SUBSTATION FORM

Station: CRESTA PH
Head Quarter: Table Mountain
Date Inspected: Jun 28, 2021 11:58:00 AM PDT
Inspected By: [Redacted]

Asset Type: ETS.TXFR
Equipment: BANK 1 A PH
Is this a Re-Inspection Form?: No

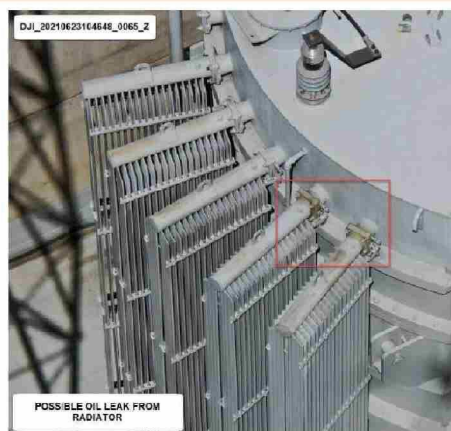
Any signs of leaks? Yes
Additional consideration may be required for this finding

↳ Describe Issue: ↳ POSSIBLE OIL LEAK

Please select all that apply Seeping

Problem Description	BK 1 A OIL LEAK
Facility/Equipment Type	Transformer/Regulator
Damage	Leaks
Action	Repair
Priority	B
Required End Date	2021-09-26
Identified in Field During	Station Inspection-DDSI
Clearance Required	Yes
Crew Class (Size)	SUB_ELE2
Est Hours	10
Est. Total Job Costs to Complete in Hrs (labor,materials,rentals, etc. - no travel time)	20
FIELD COMMENTS (Describe the work required and the equipment and the materials needed. For example: Special tools or equipment, any unusual conditions, special circumstances and supporting comments related to other information required)	BK 1 A OIL LEAKS
Select Tier	T3 Drone Inspection
ETS Type	ETS51 Repair & Return

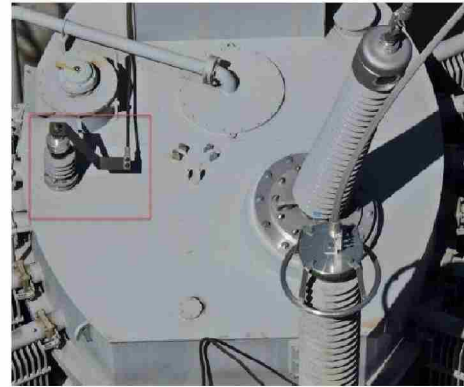
Is the H0 bushing of a lower voltage class than the H bushings? Yes

↳ Describe Issue: ↳ VISIBLY SMALLER

Non Conformances Flag Count (by Inspector)	3
SME Status	Approved
SME Notes	BK 1 A PRD FLAG OFFSET. OIL LEAK. HO IS GROUNDED NO ISSUES
A's	0
B's	2
E's	0
Non Conformances Flag Count (By SME)	2
Inspector Lan ID	[REDACTED]
Select SME (selected by Inspector)	[REDACTED]
